SUBJECT: NuScale Power, LLC Response to NRC Request for Additional Information No. 285 (eRAI No. 9205) on the NuScale Design Certification Application

NuScale Response to NRC Request for Additional Information eRAI No. 9205

eRAI No.: 9205

NRC Question No.: 15-3

Figure 1: Primary and Secondary System Interface

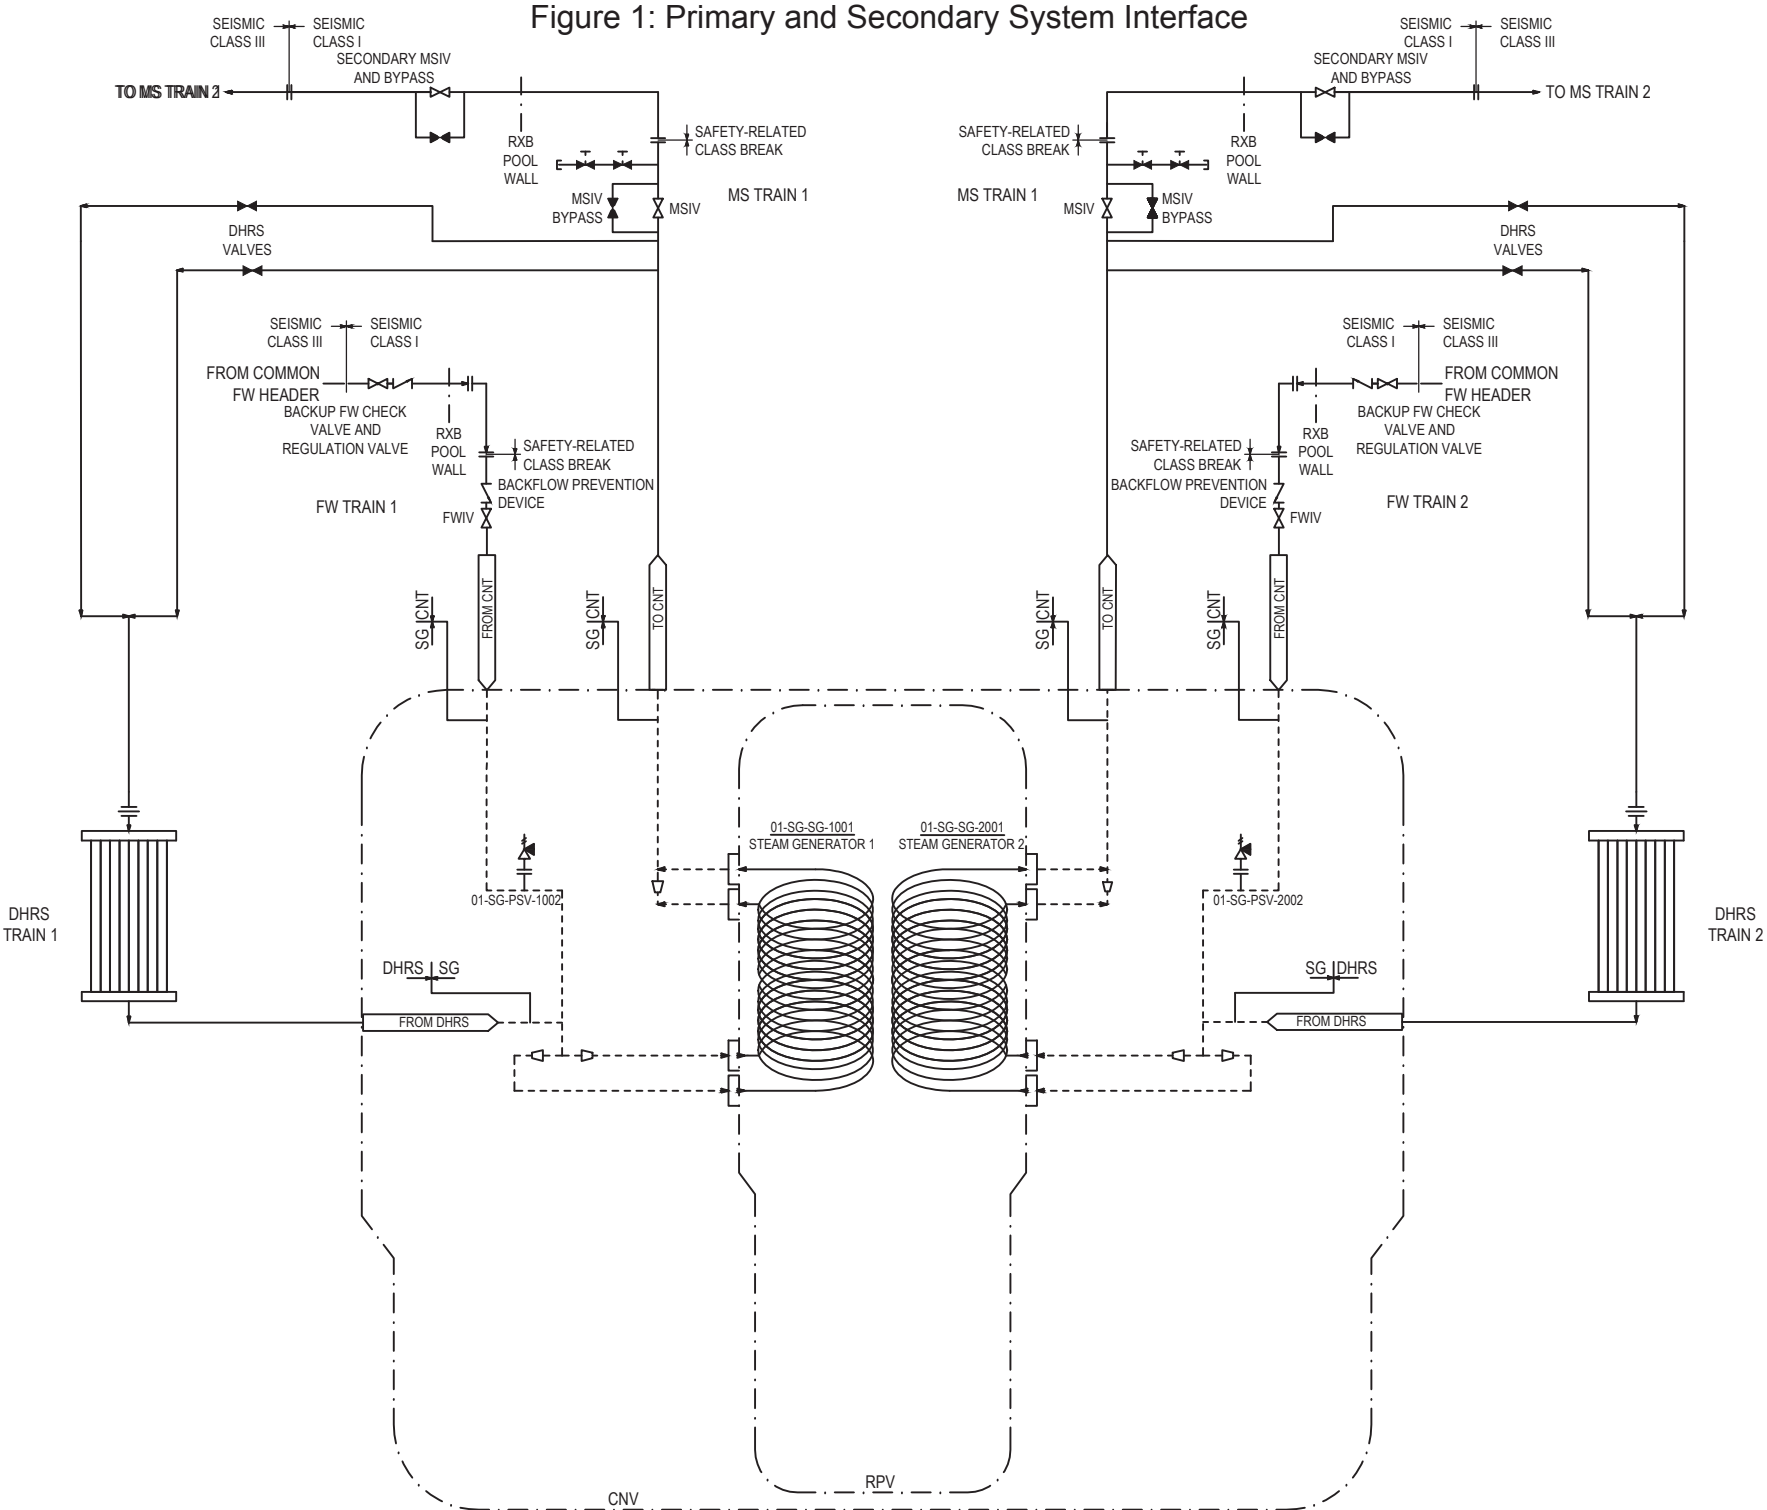
Furthermore, it is the staff's understanding that in the case of the feedwater line break inside containment, assuming no credit of the nonsafety check valve, as described in RAI 8744, Question 15.02.08-4, then there exists a potential to have both trains of DHRS inoperable which could result in core melt. The staff requests the applicant to show that for a feed line break inside containment assuming no credit of the nonsafety-related check valve, the pressure in the reactor coolant and main steam systems is maintained below 110 percent of the design values in accordance with the ASME B&PV code, and the fuel cladding integrity is maintained by demonstrating that the MDNBR remains above the 95/95 DNBR limit. If these acceptance criteria cannot be met when assuming no credit of the nonsafety-related check valve, the staff requests the applicant to provide additional information in the FSAR justifying how GDC 1 and the single failure criterion are met for this event, and clarify how the NuScale design maintains adequate defense-in-depth for its safety systems.

The limiting event for a challenge to the decay heat removal system (DHRS) operability is a large feedwater line break (FWLB) inside containment. Following a FWLB, containment pressure will increase to the containment isolation setpoint at approximately one second into the event. The safety-related check valve (backflow prevention device) in the non-faulted FW line seats at approximately one second into the event. The increased containment pressure will initiate a reactor trip and containment isolation signal and actuate DHRS approximately three seconds into the event (including sensor and signal processing time). The DHRS valves are assumed to open in 30 seconds. The FWIVs and MSIVs are designed to close within seven seconds. DHRS heat exchanger on the faulted FW line empties into containment. See Figure 1 for an integrated diagram of the systems that interface with FW system and DHRS for this event.
